PG&E Letter DCL-15-095

Diablo Canyon Units 1 and 2

Response to NRC Request for Additional Information Regarding Recommendation 2.1
of the Near-Term Task Force Seismic Hazard and Screening Report

Response to NRC Request for Additional Information Regarding Seismic Hazard and Screening Report

Figure 2-1: Potential for nonlinear amplification for PGA. The black curve is the mean amplification. The red, blue, and green curves are for the central, upper, and lower VS profiles, respectively.

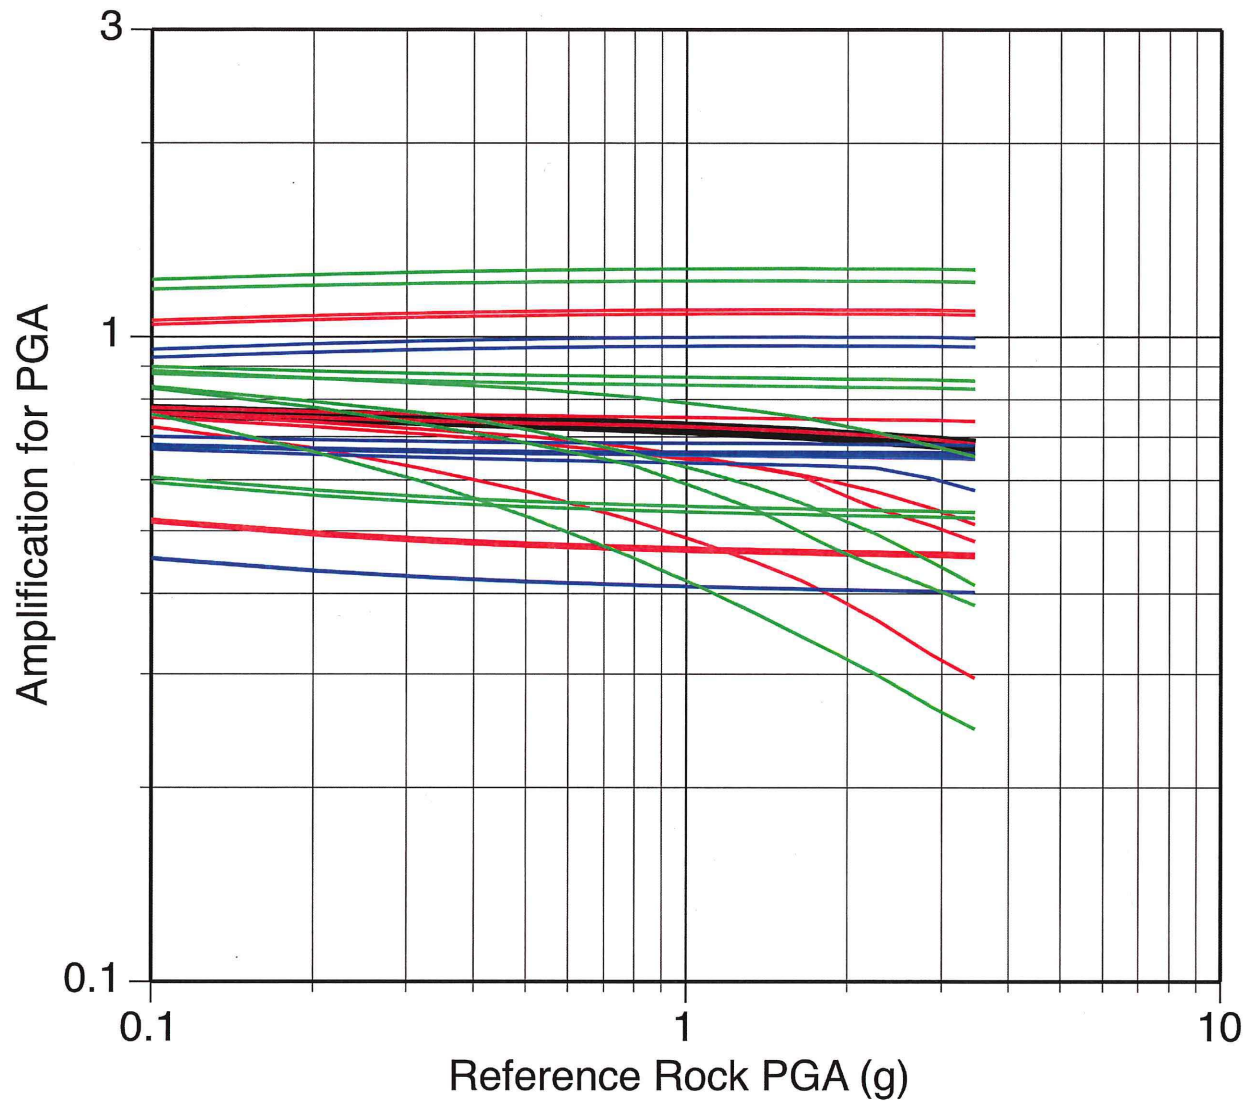
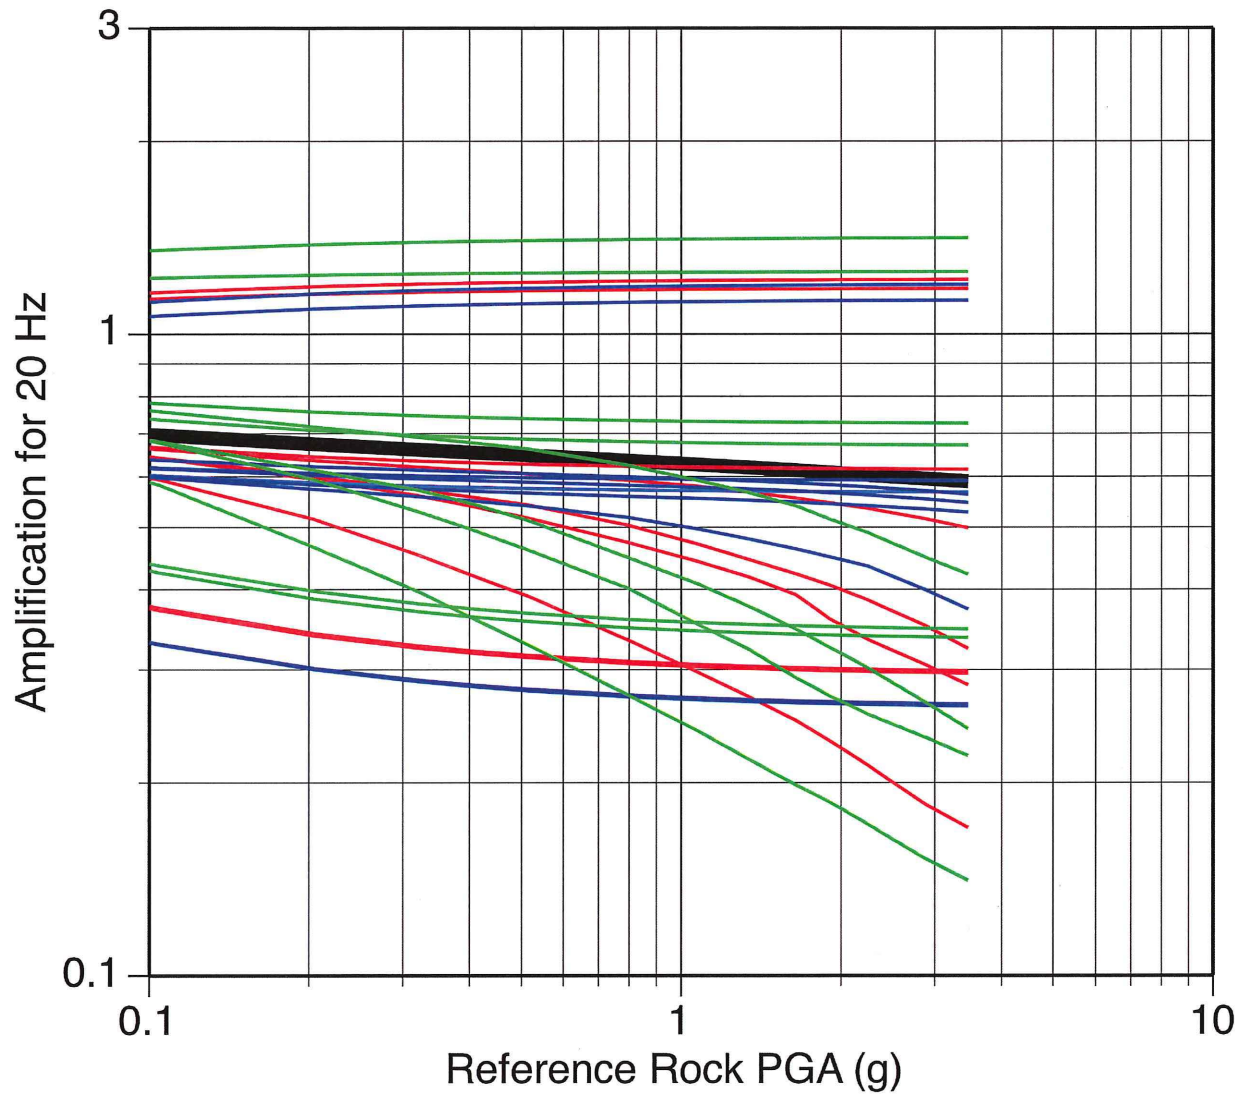
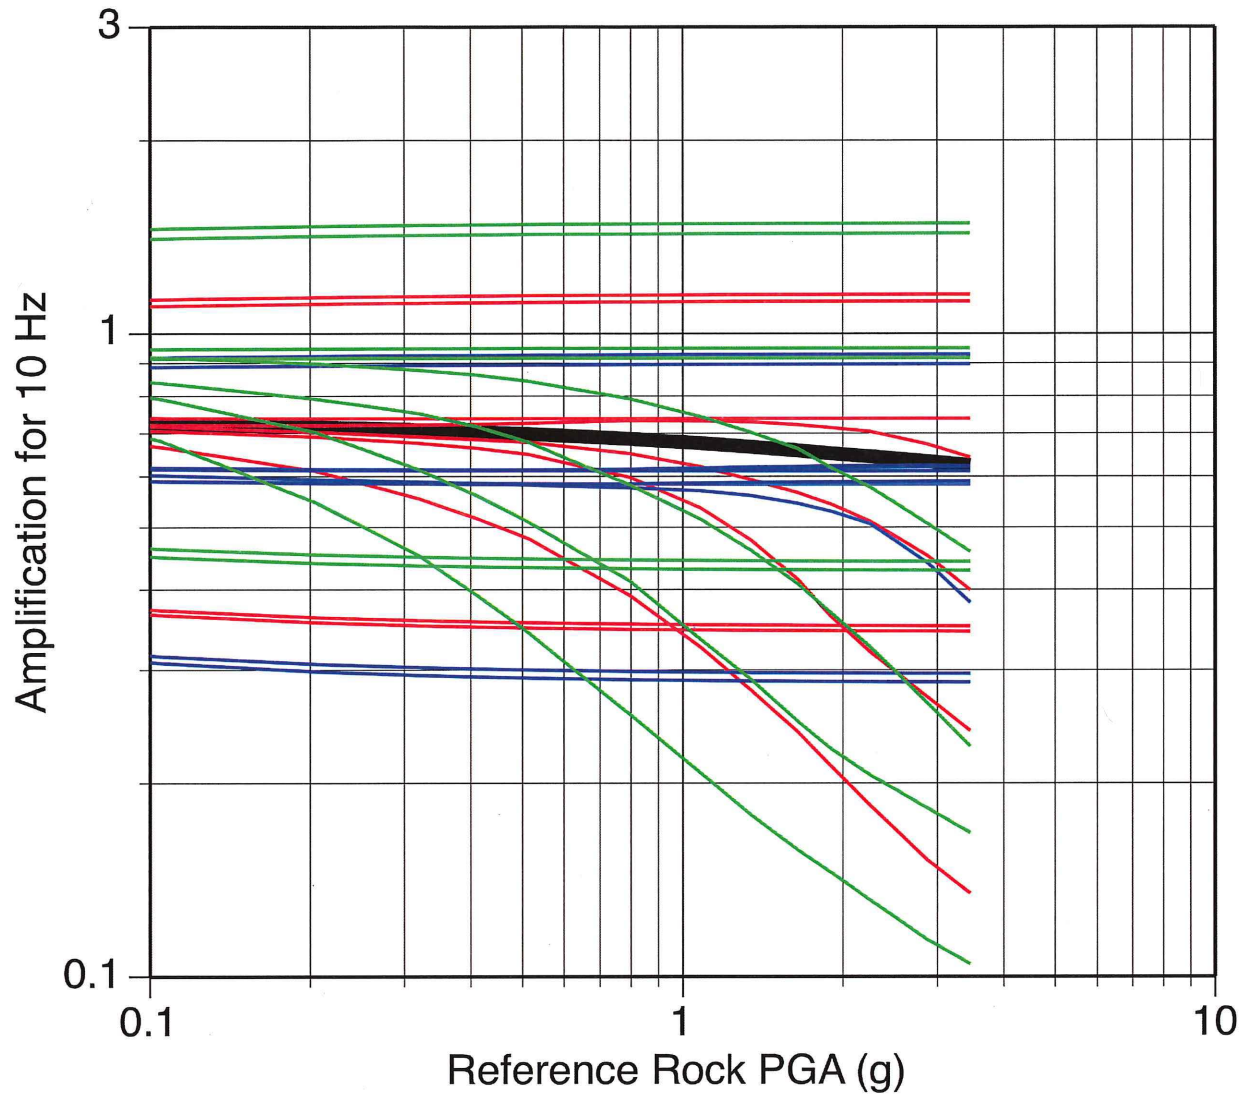
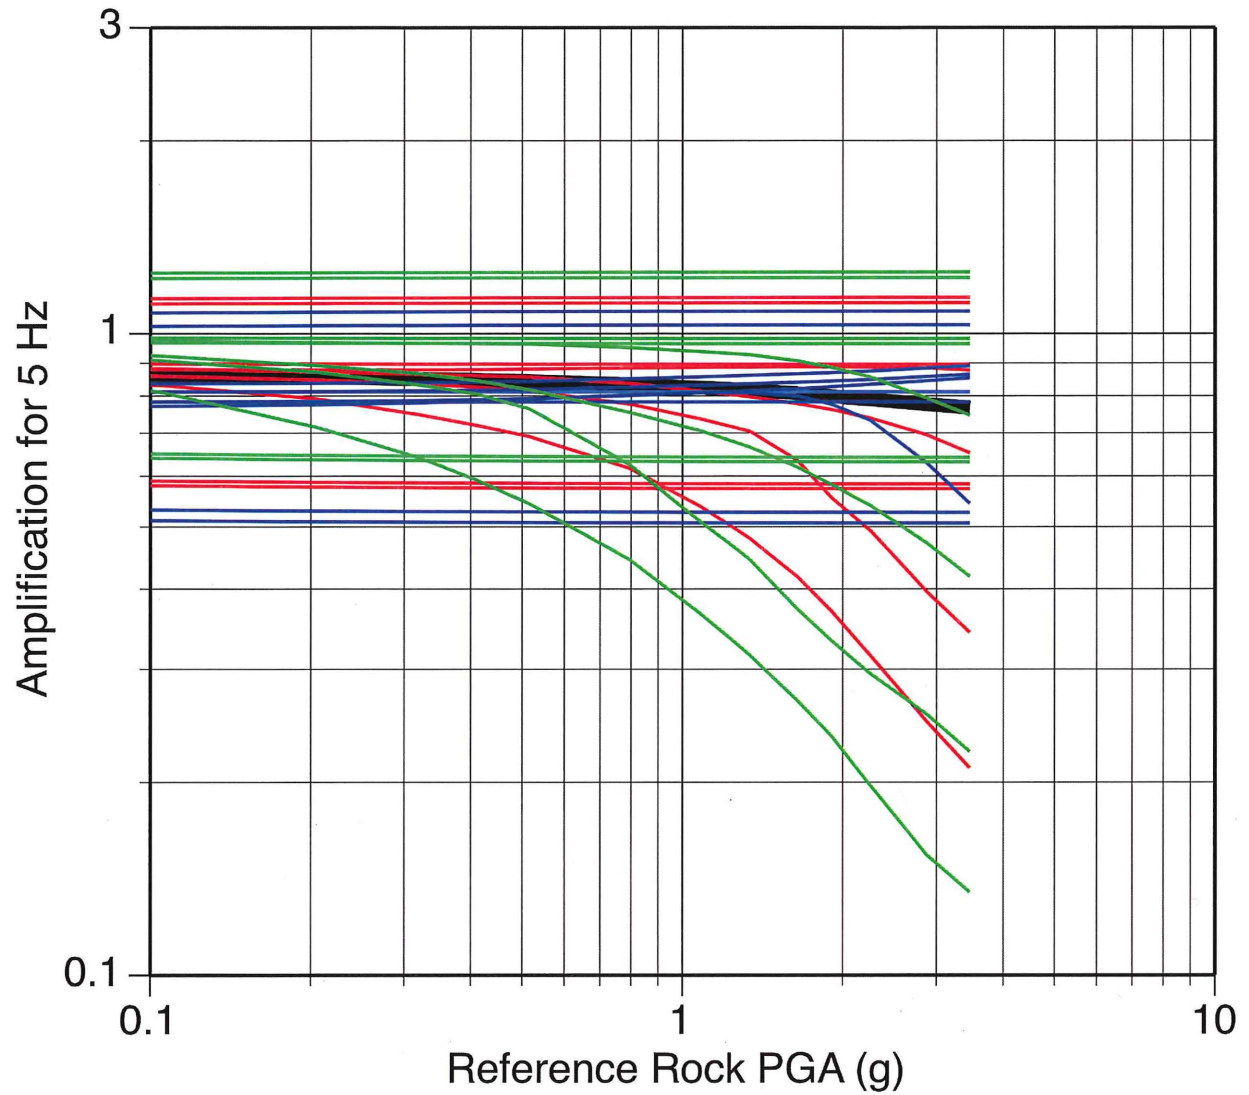
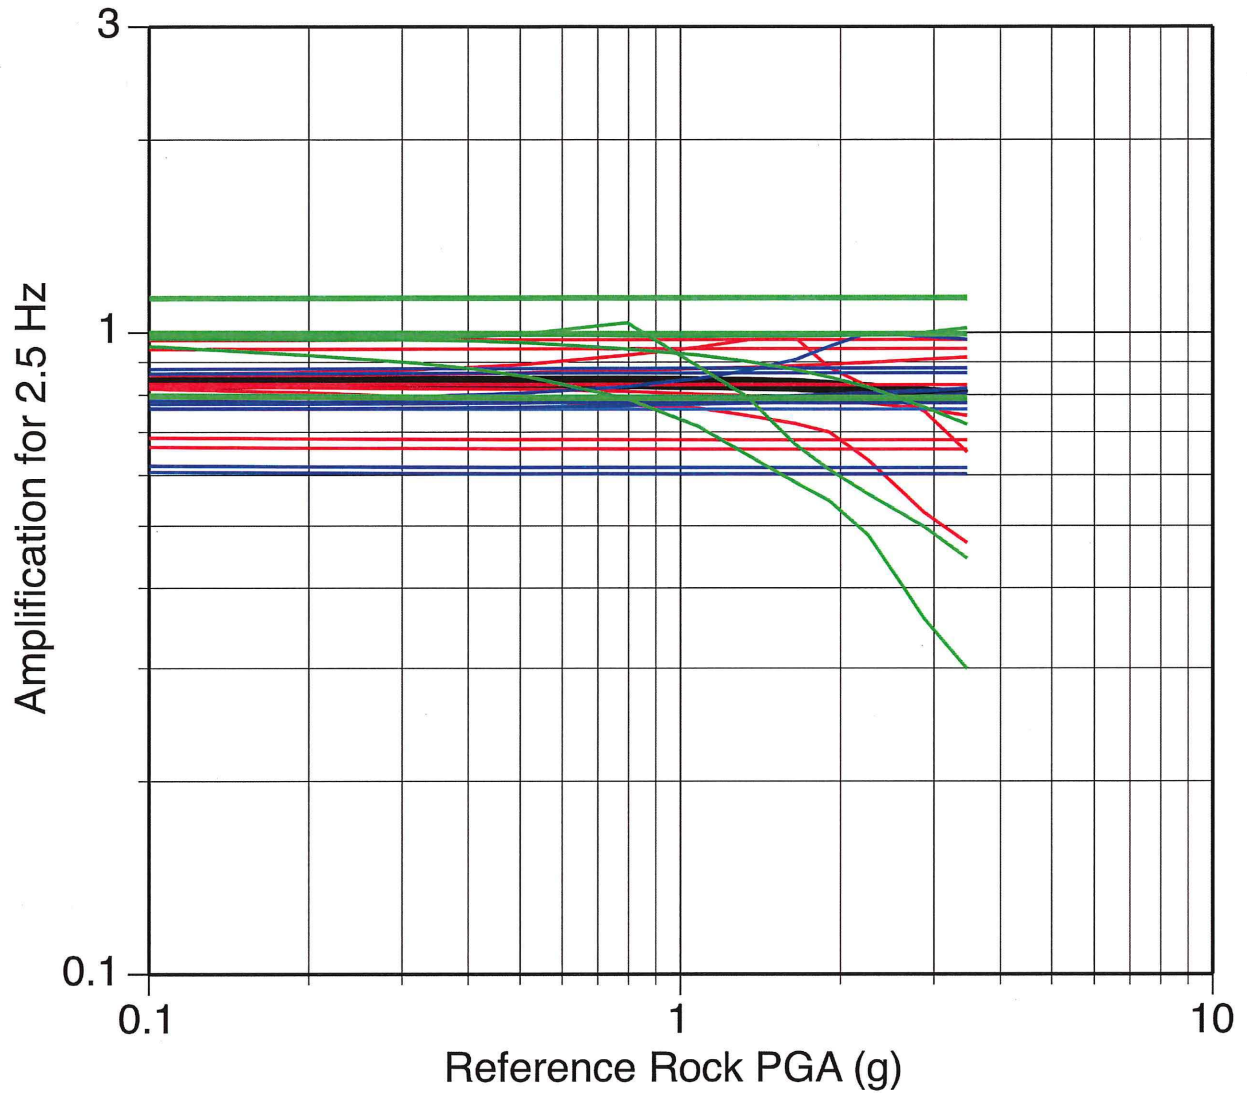
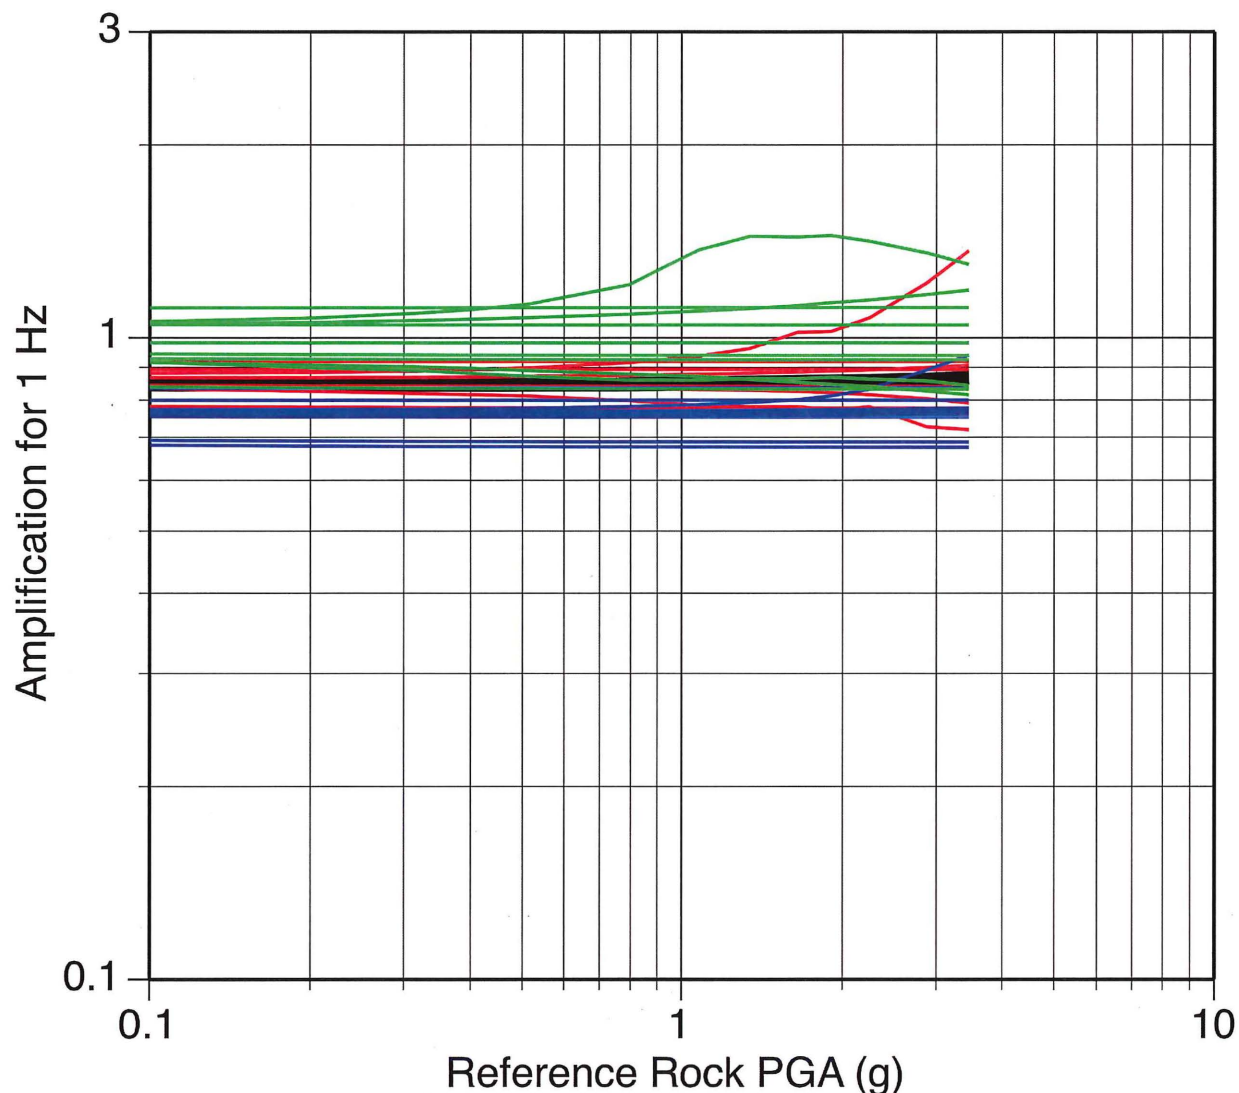
Please provide the potential for nonlinear behavior at the strain levels produced by the scenario earthquakes of interest

The potential nonlinear behavior of the rock is evaluated using equivalent linear site response (Reference 4). The resulting amplification is shown below as a function of the PSA for the reference rock condition ($VS_{30} = 760$ m/s with linear site response) for PGA and 5 spectral frequencies (1 Hz, 2.5 Hz, 5 Hz, 10 Hz, and 20 Hz) in Figures 2-1 to 2-6. The range of the amplification for the 30 alternative models of the VS, κ , and material properties is shown for each frequency. For reference, the $1E-4$ hazard for the reference rock case corresponds to a peak acceleration of about 1 g.
